Baridhi Garments Ltd. (Extension)

SFB#8, Cumilla EPZ, Cumilla-3500, Cumilla
(23.443694, 91.183057)
25 July 2023

Observations

Absence of design Report

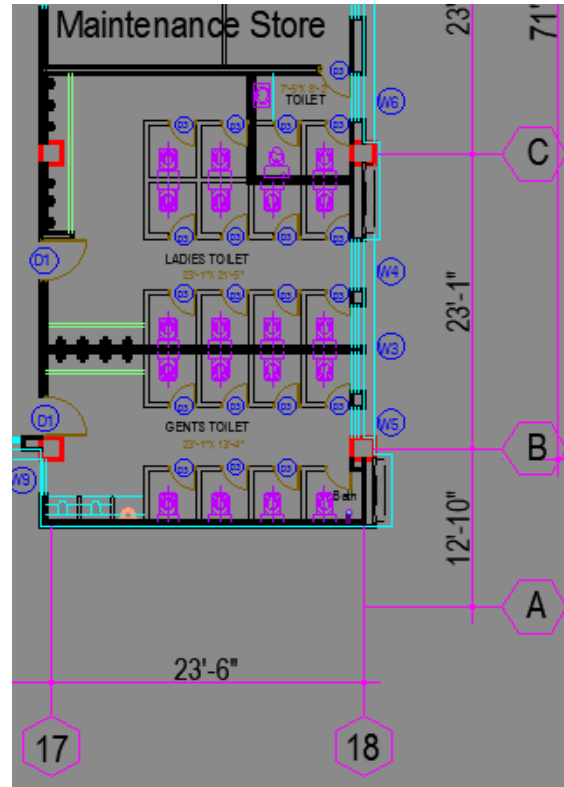
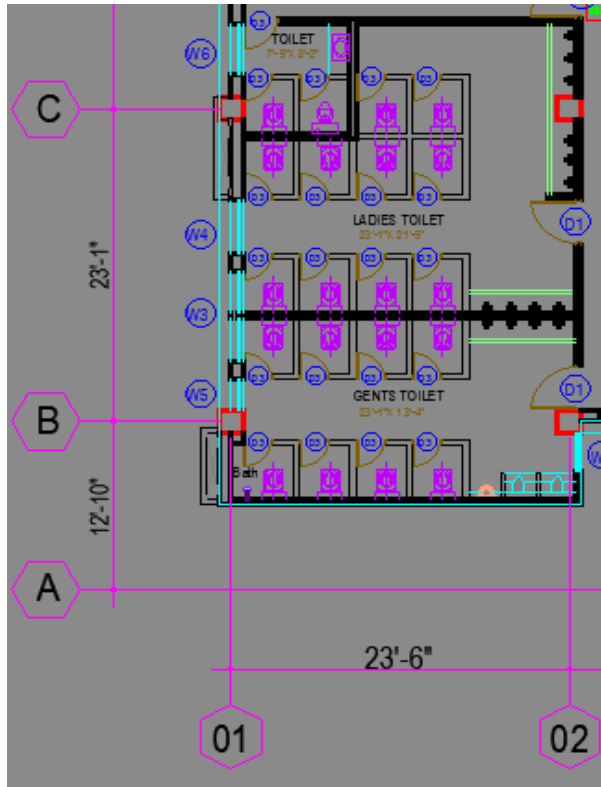
As per BNBC every building or structure designed shall have its design documents prepared in accordance with the provision of Section 1.9.1. The design document shall include a design report, and a set of structural drawings, which shall be prepared in compliance with section 1.9.1.1 and section 1.9.1.2 as per BNBC. Design report was not found which is required to be prepared in compliance with section 1.9.1.1 (part-6, BNBC).

Architectural layout for toilets

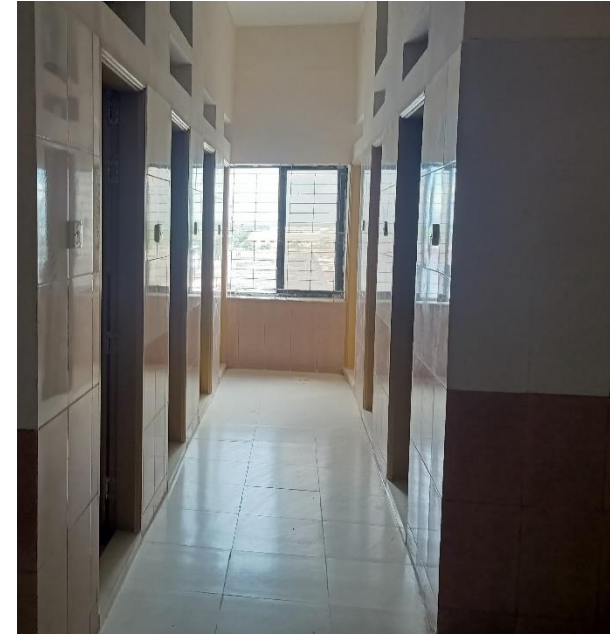
The location and numbers of toilet shown in the drawing are not matching with the site condition. As well as built up and some other occupancies are required to be updated in the drawing. Building engineer is required to survey the whole structure and update the as-built drawing.
